APPLICATION No. **21/00049/MJR** APPLICATION DATE: 06/08/2021

APPLICANT: Velindre NHS Trust & Asda Stores Ltd
LOCATION: ASDA CORYTON, LONGWOOD DRIVE, WHITCHURCH,
CARDIFF

PROPOSAL: DISCHARGE OF CONDITIONS 3 (ARBORICULTURAL
METHOD STATEMENT AND TREE PROTECTION
PLAN) AND 4 (SOFT LANDSCAPING) OF
20/01108/MJR

Tree Planting & Landscaping Plan

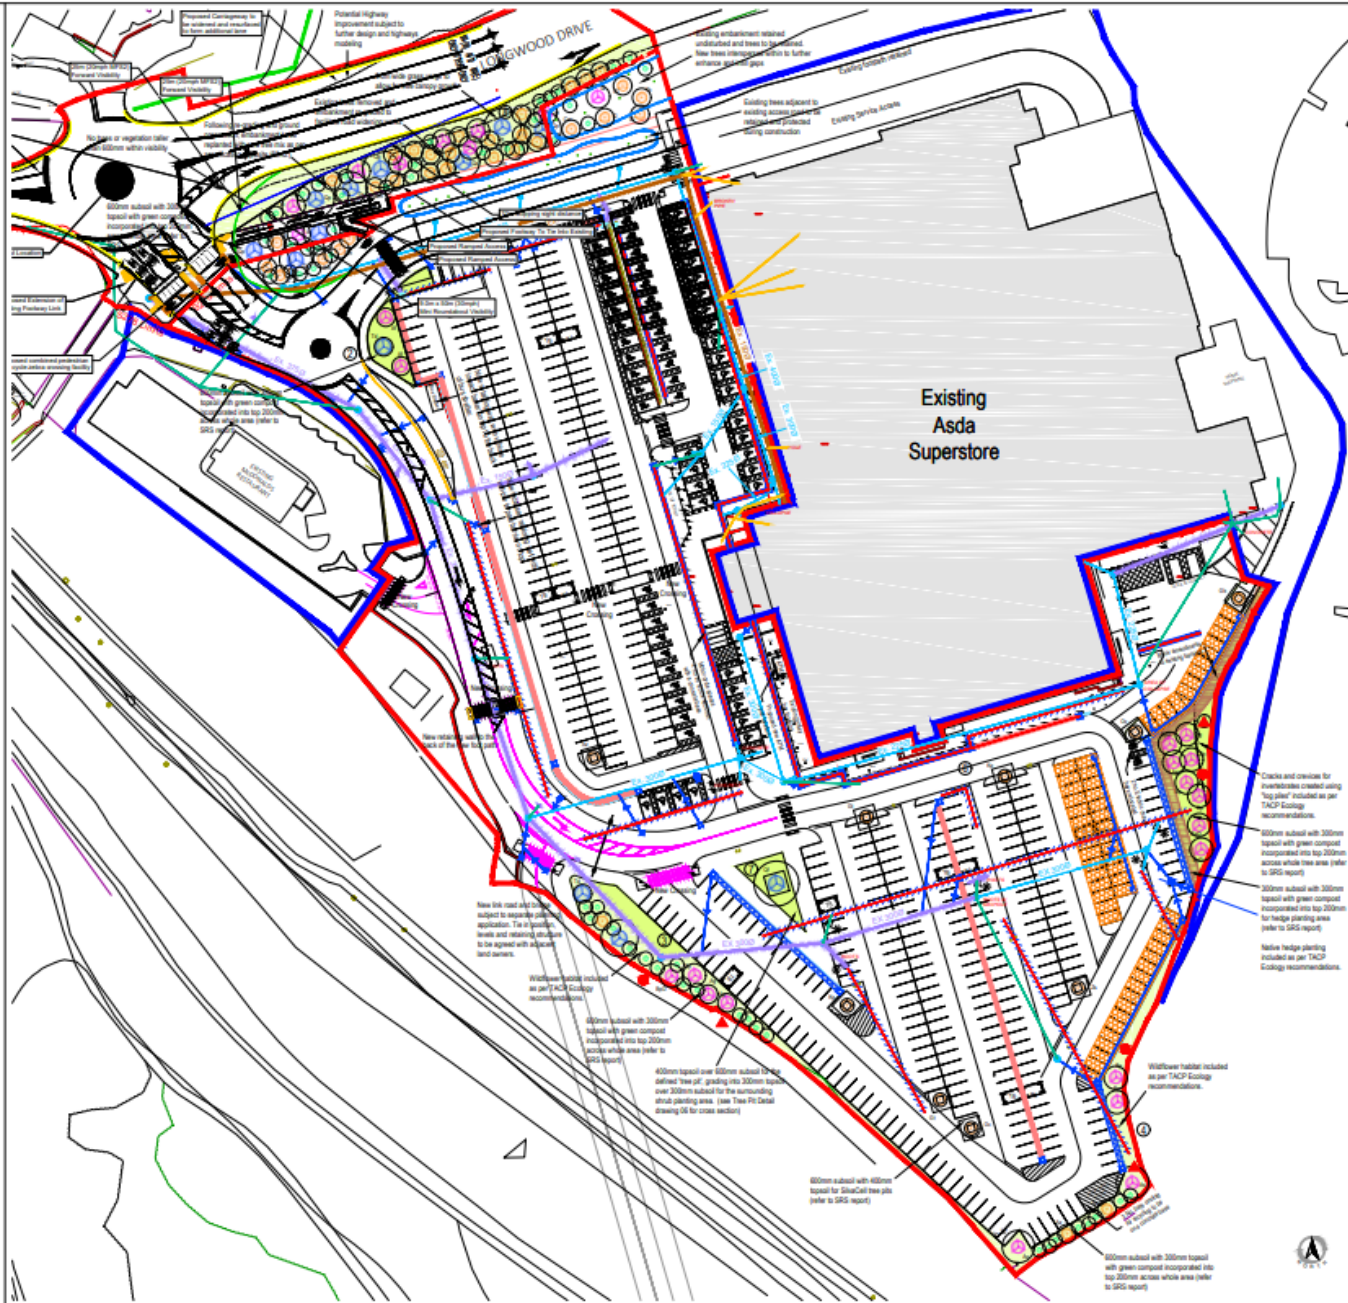
The submitted documents and plans, as outlined in the recommendation 1 above, have been amended to overcome the concerns of the County Tree Officer who raised concerns that the too many trees were proposed within too small an area.

The above amended details have been considered by the County Tree officer and overcome his concerns regarding the planting of too many trees into too small a space which would have undermined future growth.

The amended plans have overcome my concerns and based upon the amended plans, I raise no objections.
